LEXINGTON-FAYETTE URBAN COUNTY GOVERNMENT CONTRACT CHANGE ORDER Page 1 of 11		Date:	October 1, 2025
To (Contractor):		Project:	Clays Mill Road Improvements, Section 1
L-M Asphalt Partners, Ltd.		Location:	CMR - Waco to Harrodsburg
dba ATS Construction		Contract No.	17-2020
3009 Atkinson Ave, Suite 400, Lexington, KY 40509		Original Contract Amt.	\$10,683,653.39
		Cumulative Amount of Previous Change Orders	\$1,373,272.58
		Percent Change - Previous Change Orders	12.85%
		Total Contract Amount Prior to this Change Order	\$12,056,925.97
		Change Order No.	5 - Final
You are hereby requested to comply with the following changes from the contract plans and specification;			
Current Change Order

LEXINGTON-FAYETTE URBAN COUNTY GOVERNMENT CHANGE ORDER				DATE:		October 1, 2025
Change Order #:						5 - Final
CONTRACT #:						17-2020
Project: Clays Mill Road Improvements, Section 1						
You are hereby requested to comply with the following changes from the contract plans and specifications;

Clays Mill Road Improvements, Section 1
Change Order No.5 - Final
Reasons for Porposed Changes

2224 Clays Mill Road
Driveway Reconstruction
1" = 5' on 11 x 17 sheet

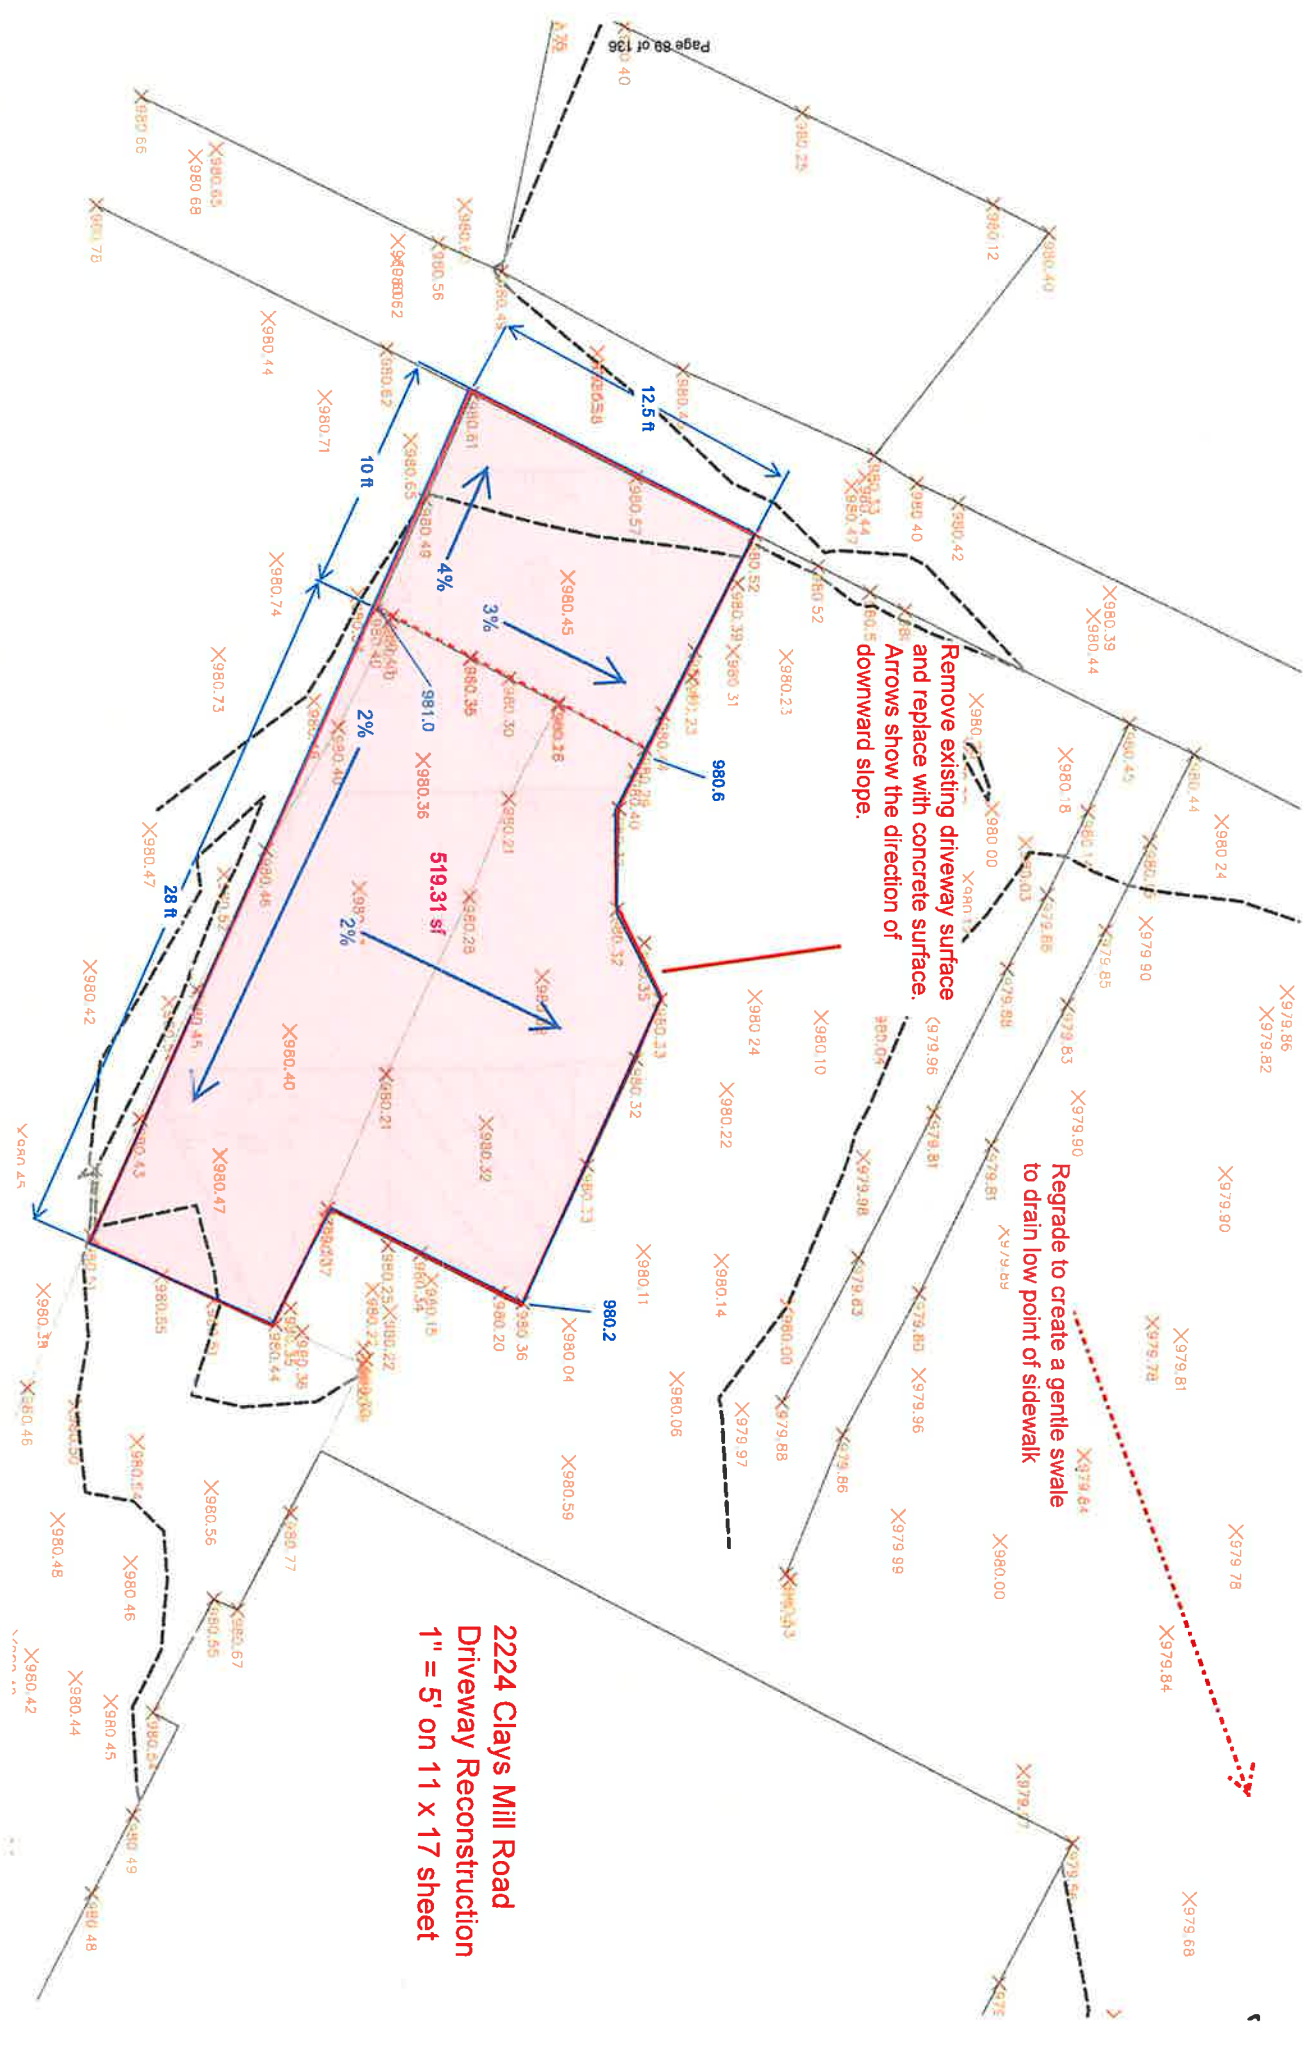
Remove existing driveway surface and replace with concrete surface. Arrows show the direction of downward slope.

Nyloplast Drain Basin with Add-a-branch

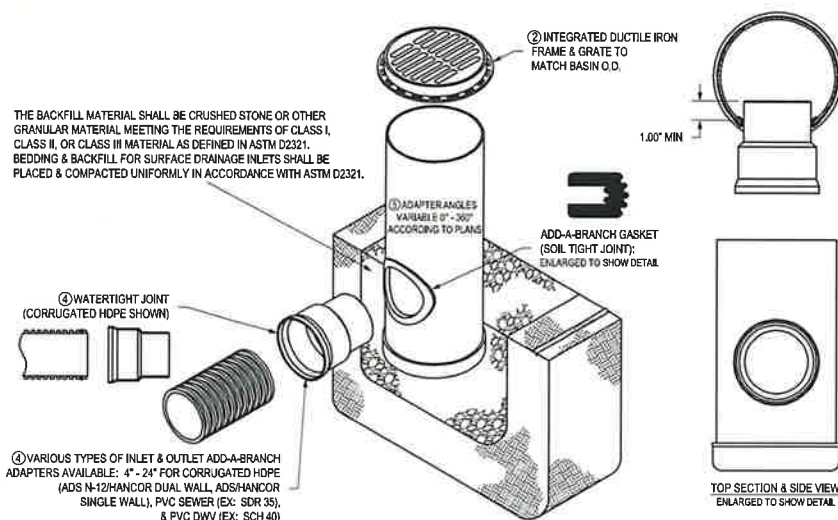
Dylan,
We want to go back to the inlet concept.
